SH-BCU-66

CADDY NO. 1398 ITEM NO. 12

JOB: UNIVERSITY HOSPITAL OF CLEVELAND
LOC: CLEVELAND, OHIO
CUST:
CUST#:

DWG# D-1-1398 SHT 1 OF 7

SH-BCU-54

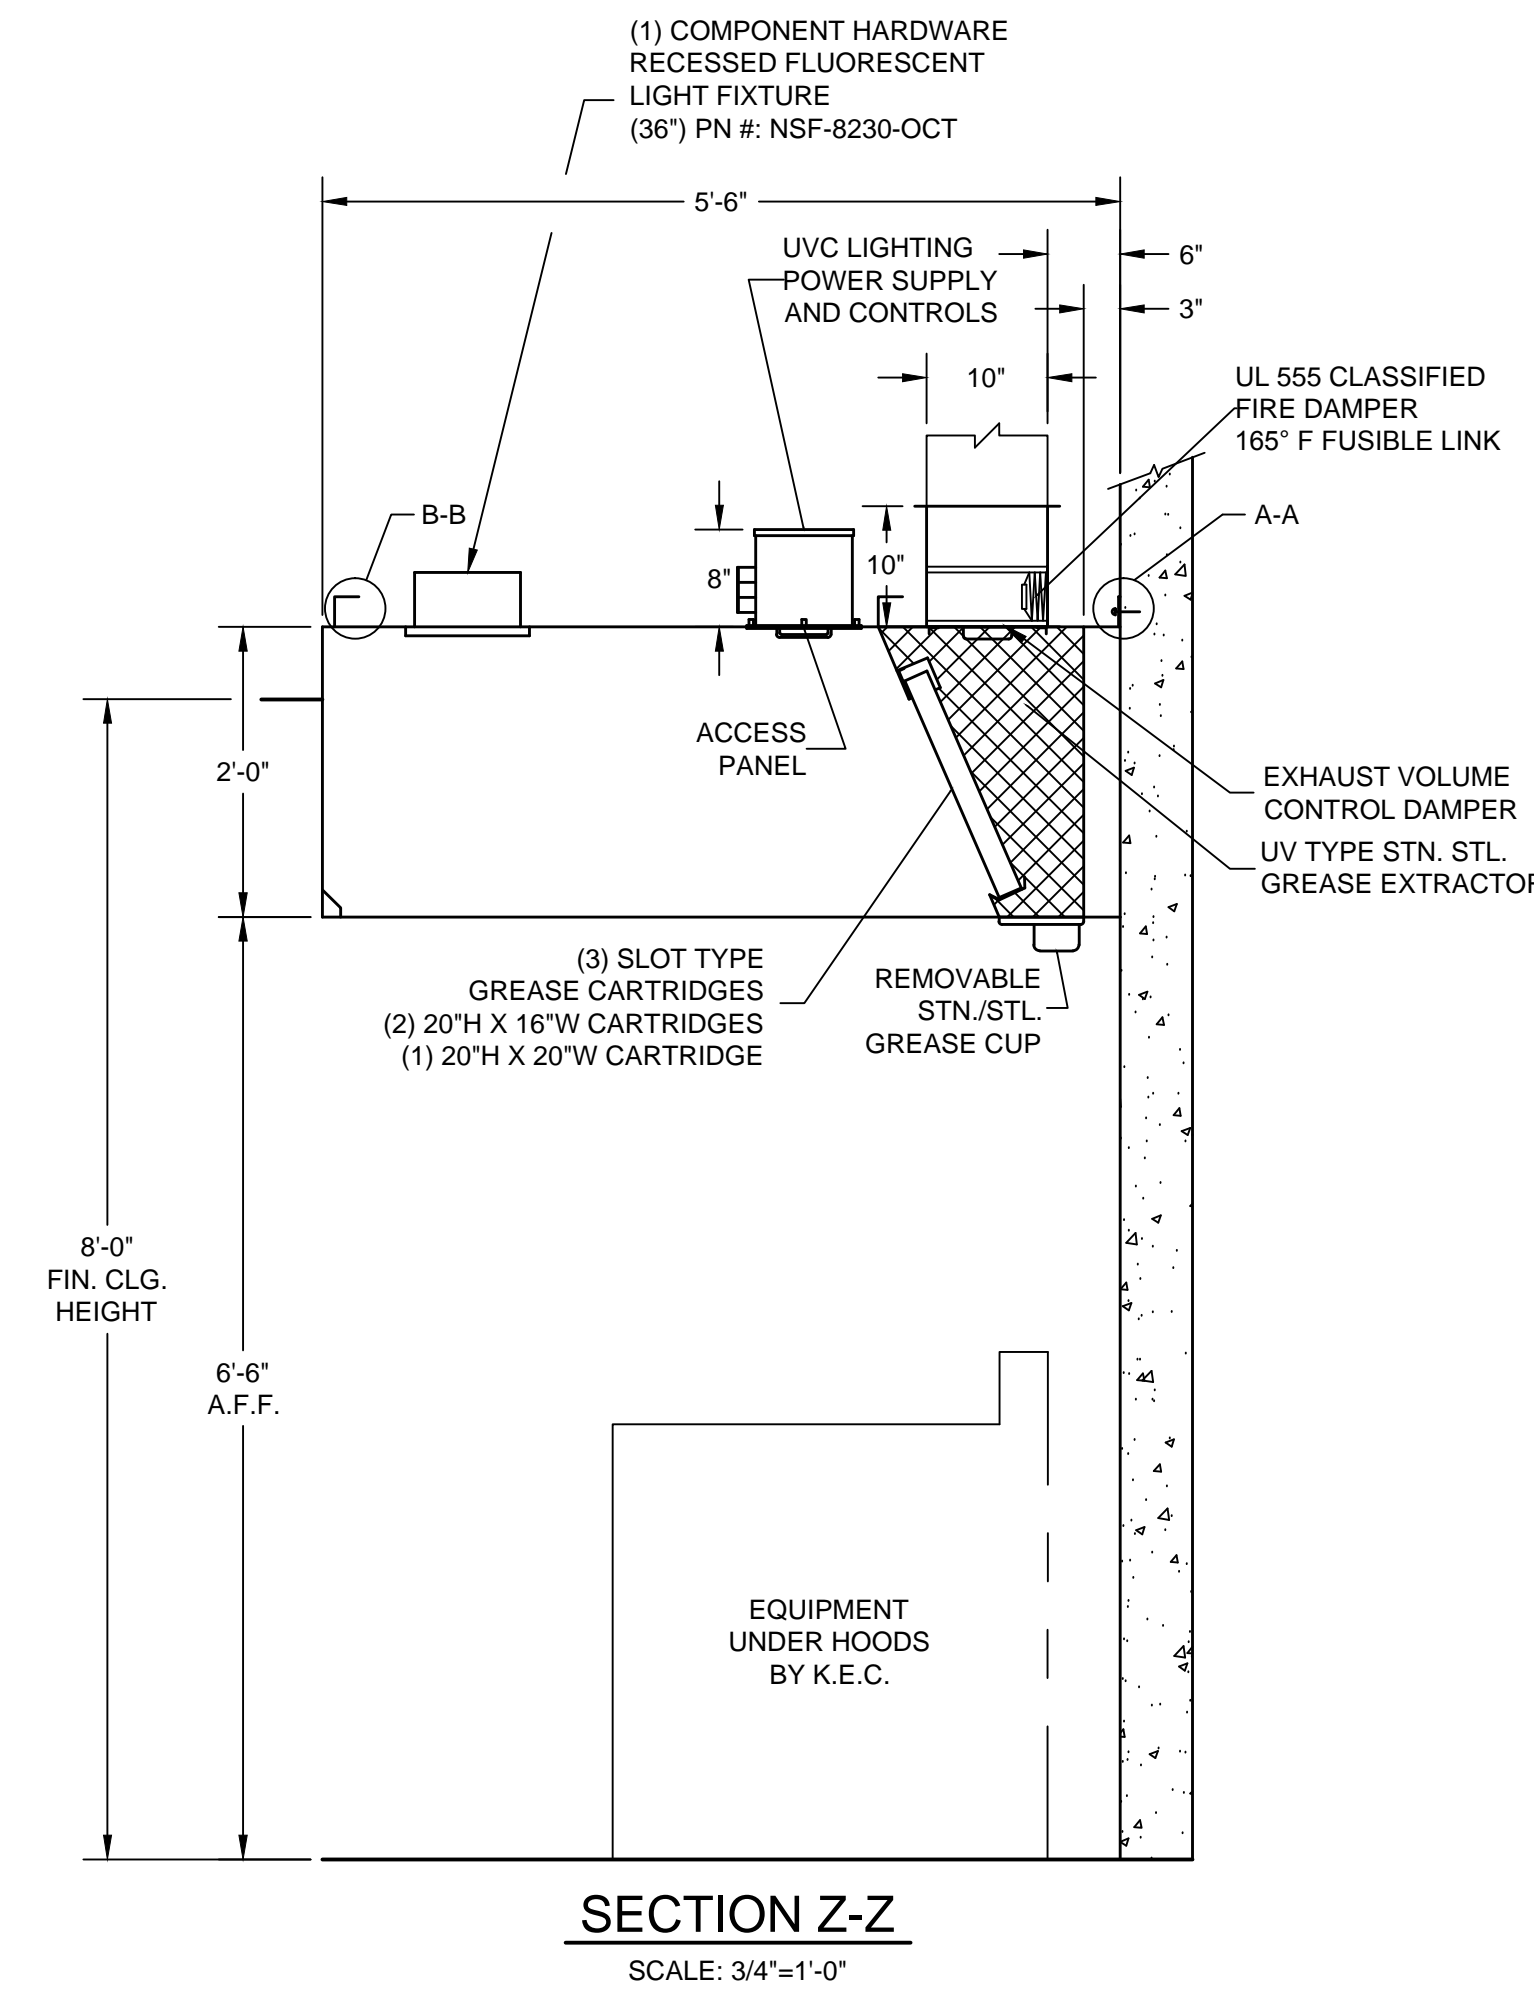
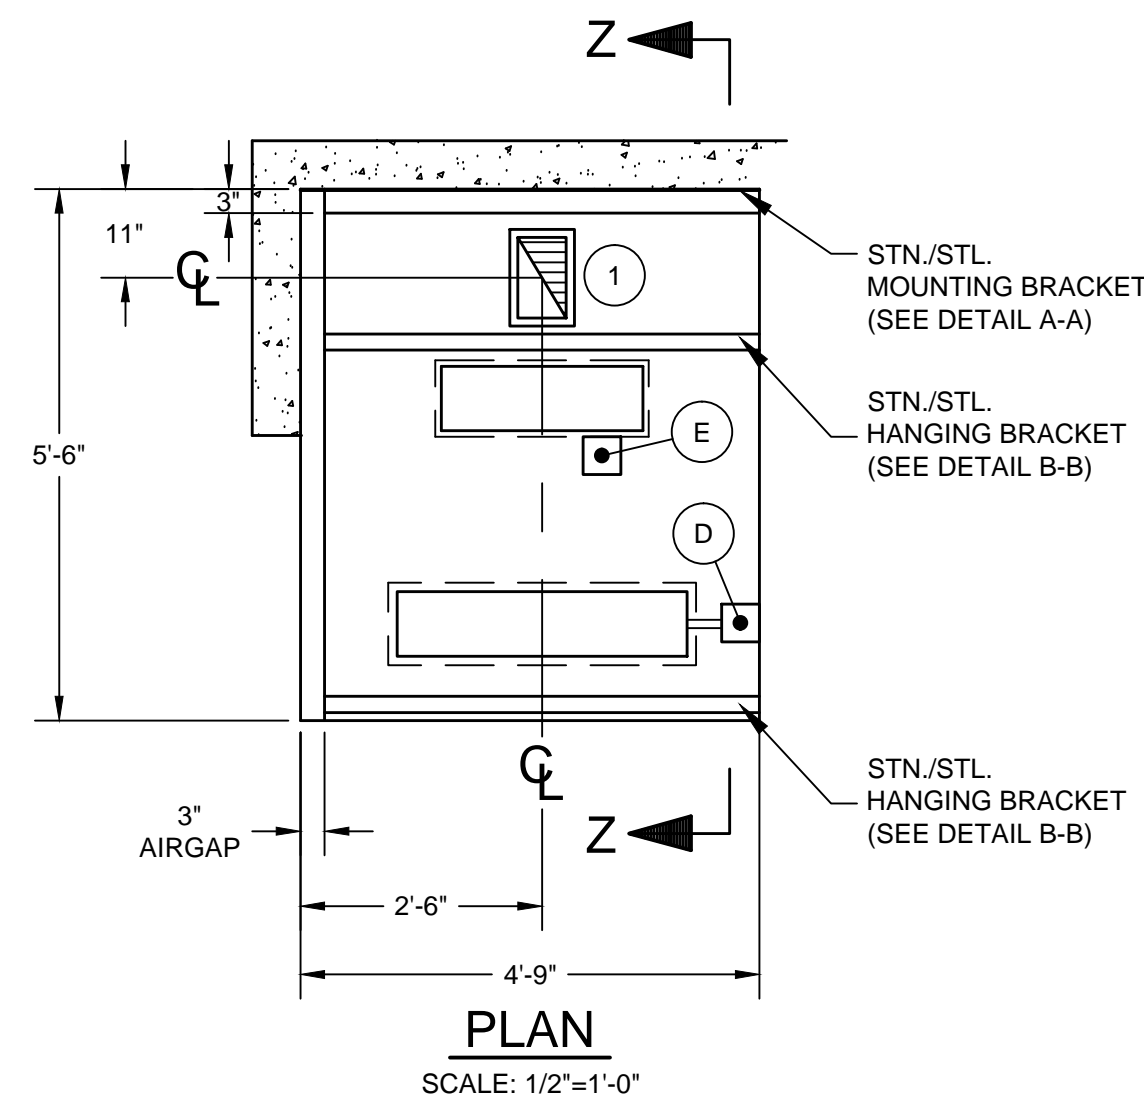
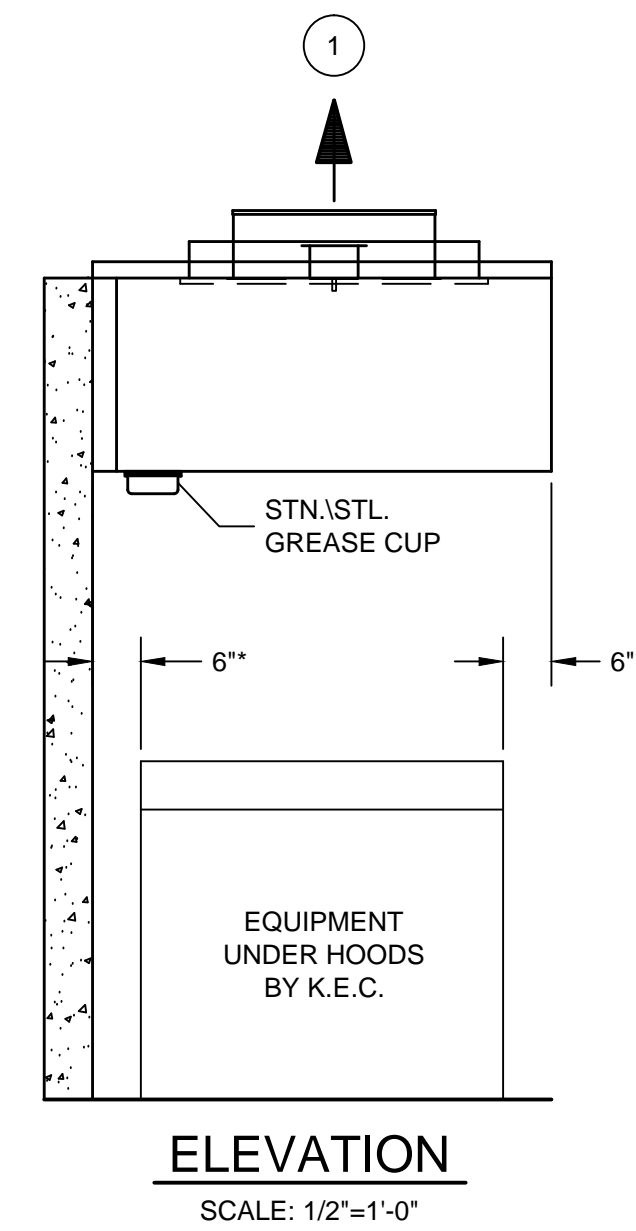
REVISIONS			
REV	DATE	BY	REMARKS
A	9-24-04	SWL	REVISED PER PHONE CONVERSATION WITH PAUL BERINSKY OF H-MAK ON 09/24/04. REVISED THE VENTILATOR'S HEIGHT FROM 30" TO 24". REVISED THE FINISHED CEILING HEIGHT FROM 9'-0" TO 8'-6".
B	9-29-04	SWL	FABRICATED PER APPROVED DRAWING FROM PAUL BERINSKY OF H-MAK ON 09/27/04. REVISED FINISHED CEILING HEIGHT FROM 8'-6" TO 8'-0".
C	10-8-04	SWL	NO CHANGES TO THIS SHEET
D	11-29-04	SWL	NO CHANGES TO THIS SHEET

SH-BCU-60

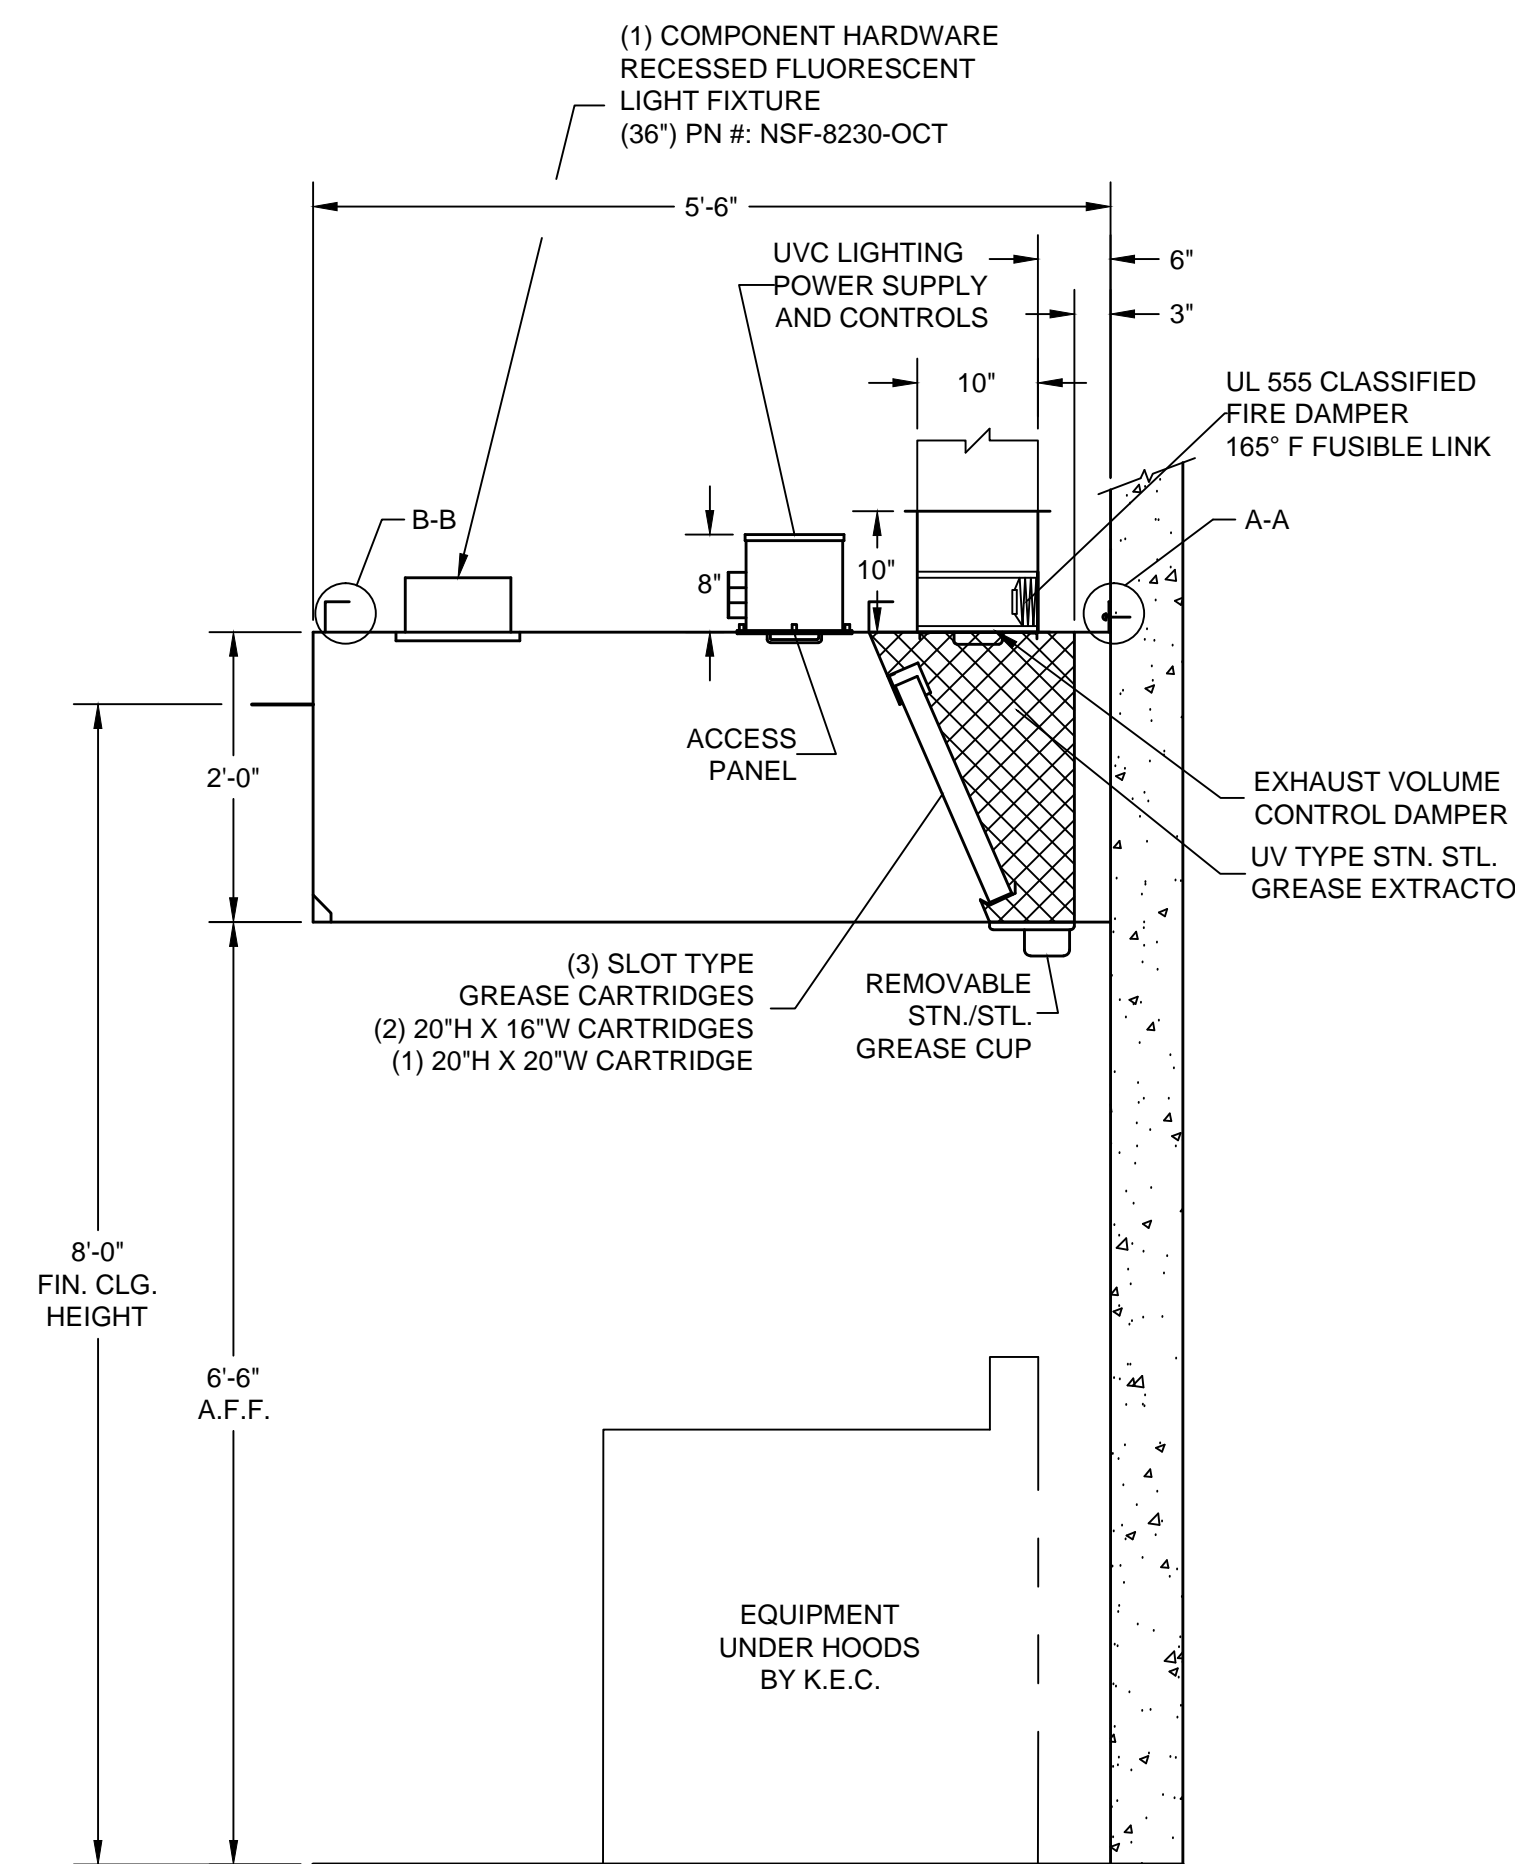
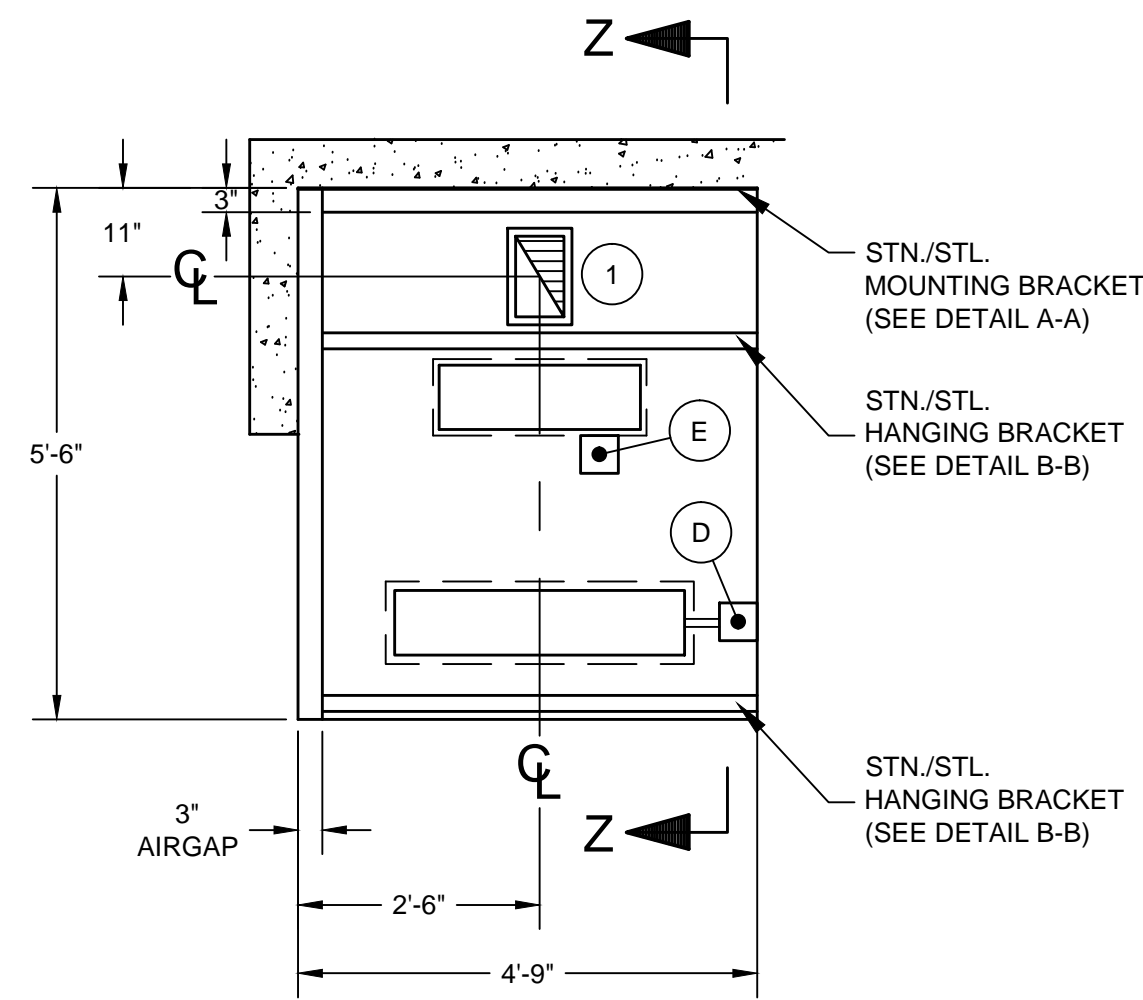
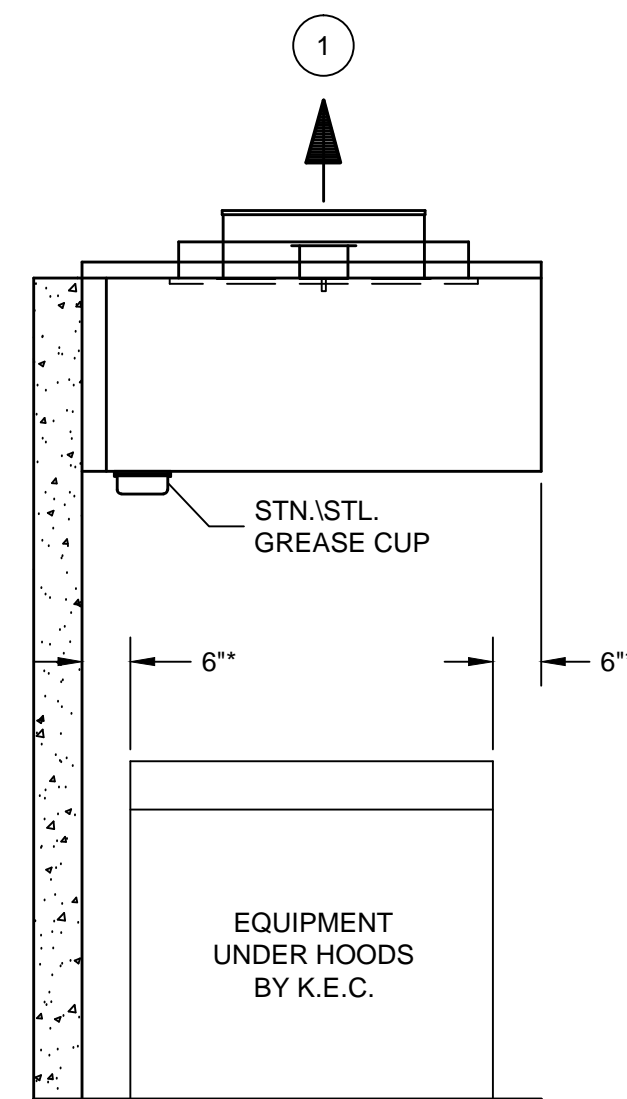
REVISIONS			
REV	DATE	BY	REMARKS
A	9-24-04	SWL	REVISED PER PHONE CONVERSATION WITH PAUL BERINSKY OF H-MAK ON 09/24/04. REVISED THE VENTILATOR HEIGHT FROM 32" TO 24" REVISED THE CUSTOMER SIDE OF THE VENTILATOR TO SHOW A CURVED WALL. THE CURVED FRONT WALL AND SIDE WALLS ARE 7'-0" ABOVE FINISHED FLOOR.
B	9-29-04	SWL	FABRICATED PER APPROVED DRAWING FROM PAUL BERINSKY OF H-MAK ON 09/27/04. REVISED FINISHED CEILING HEIGHT FROM 10'-2" TO 9'-0" BULKHEAD ON THE SIDES OF VENTILATOR @ 7'-0" A.F.F.
C	10-9-04	SWL	NO CHANGES TO THIS SHEET
D	11-29-04	SWL	NO CHANGES TO THIS SHEET
